Product specifications

342178

Wall Designheat 2000

KPT-2000C 0505L

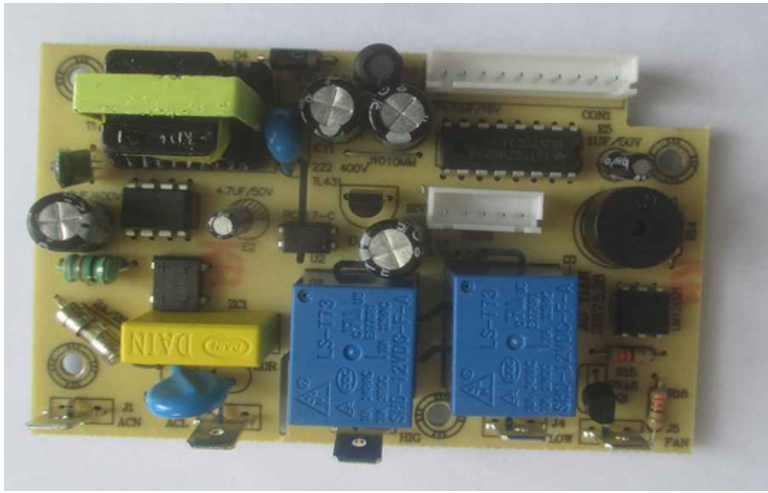
```
Roy 11:37:59
 · becasue same engineer write the program for these items
 · checked with enginner,he told when the environment temperature change more than 2 degree it will send signal to APP
Gert 11:38:46
 · good
 · this system also can do for Aoch?
Roy 11:39:26
    yes
Gert 11:39:46
    👍
```

Change PCB , when 2 or more degree difference PCB will send signal to APP Will change.

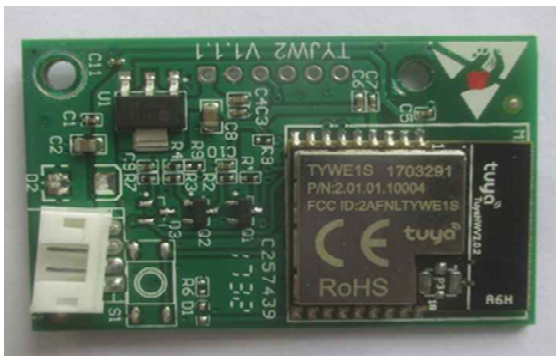
App without Countdown timer and with swing function and heatpositions

It is only smart timer

No countdown timer

So for this model if we do only Smart timer but no countdown timer is ok?

MODEL: YYHS40
220V~240V 50Hz
40W 1350r/min E
C=0.8µF

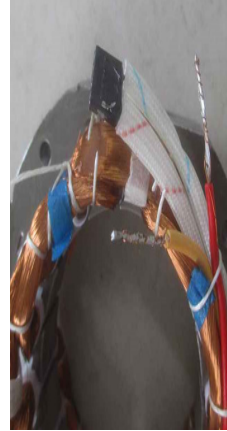
Motor: YYHS40 220-240V 50Hz 40W 1350r/min, class ??   What is motor class?Class 120

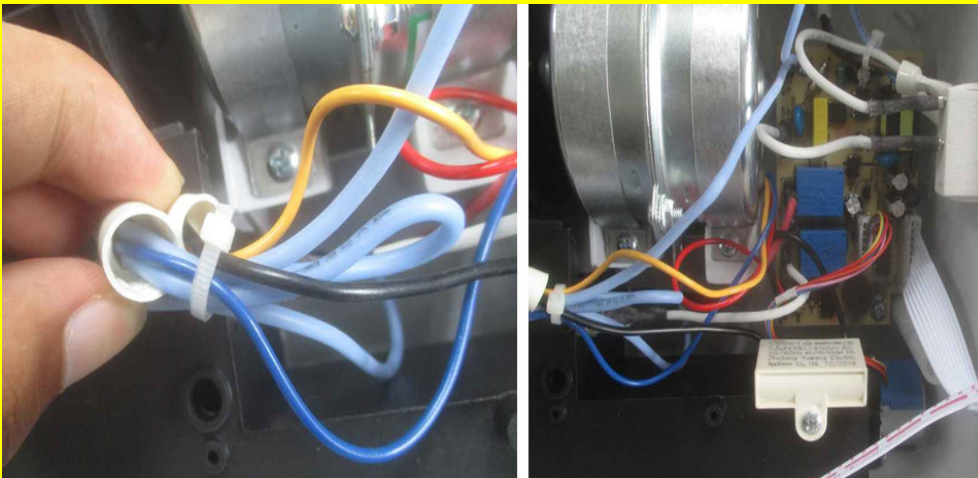
All-fast on connectors and crimp connectors have to be minimum 3 mm from plastic housing

Crimp connectors 3 mm from housing or is housing 850 degree GWT approved?Can pass.

15 mm   DO NOT COVER / NIET AFDEKKEN   3 mm

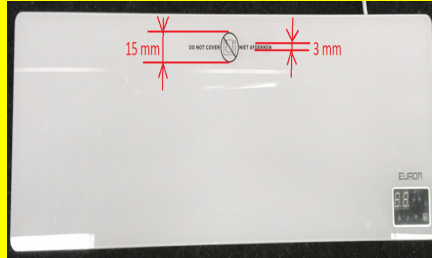
Do not cover silkscreen logo with 2 languages (English and Dutch), *__Text size MAX 3 mm. Logo size MAX 15 mm__* . color from silkscreen grey 11C
Position from silkscreen as on picture

Last received stock, the silkscreen was too big. Please adjust to maximum dimensions of 3mm text and 15mm logo size.
